### SCHEDULE "PE"

### PURCHASER'S EXTRA

KINGSMEN (THAMES) INC.

# Lot 45 Phase: 4B Plan: Draft Approval SB17-03-08 Model: Spencer (4204) Elev C 4 Bed - 4+1 Bath

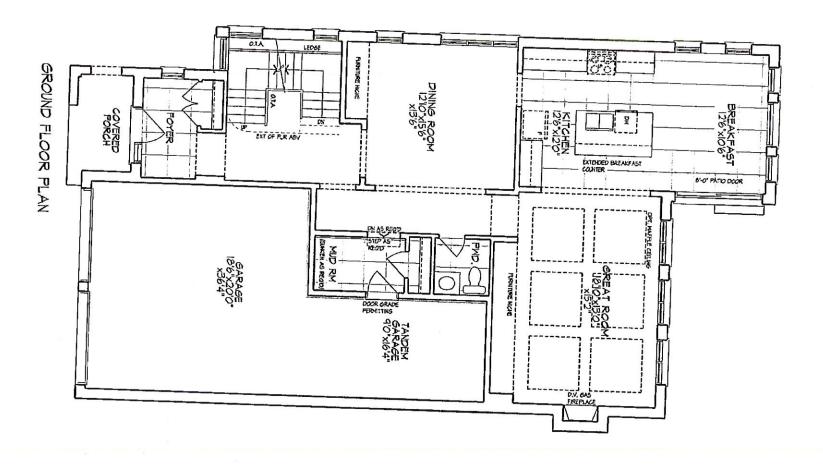
13 11 10 00 7 6 ^ S Vendor to replace single door entry to home with a double door, 8 feet tall. As Per plan, there will be no side lights and no transom on top of the front doors. VENDOR TO INCLUDE ENGINEERED HARDWOOD FLOORING TEROUGHOUT THE SECOND FLOOR IN LIEU OF INCLUDED CARPET, AS PER PLAN, AND SELECTIONS AS OUTLINED IN SCHEDULE A FOR INCLUDED ENGINEERED HARDWOOD ON THE MAIN FLOOR. THIS HAS NO CASH VALUE VENDOR TO INCLUDE LEVEL 1, 2CM GRANITE OR QUARTZ IN ALL BATEROOMS, AS PER PLAN, IN LIEU OF THE INCLUDED LAMINATE COUNTER TOPS. SELECTIONS TO BE MADE FROM BUILDERS STANDARD SAMPLES. VENDOR TO SUPPLY & INSTALL AIR CONDITIONING UNIT, SIZED ACCORDINGLY, FROM VENDORS STANDARD SAMPLES. VENDOR TO INSTALL GAS LINE (ROUGH-IN ONLY) TO KITCHEN IN AT STOVE LOCATION (AS PER PLAN) TO INCLUDE 110V CODE REQUIREMENT. VENDOR TO INSTALL CAPPED GAS LINE (ROUGH-IN ONLY) AT REAR OF HOME FOR FUTURE BBQ LOCATION. LOCATION TO BE FINALIZED AT VENDORS SOLE DISCRETION. 5 FREE APPLIANCES - STAINLESS STEEL FRONT - FRIDGE; STOVE AND DISHWASHER. WHITE WASHER AND DRYER (SUPPLIED ONLY, NOT INSTALLED, FROM BUILDERS STANDARD LINE). BOY APPLIANCES VOUCHER WILL BE GIVEN BY OUR DECOR CONSULTANT AT THE TIME OF BOOKING YOUR COLOUR APPOINTMENT. See Sketch. This will mean, ABAD
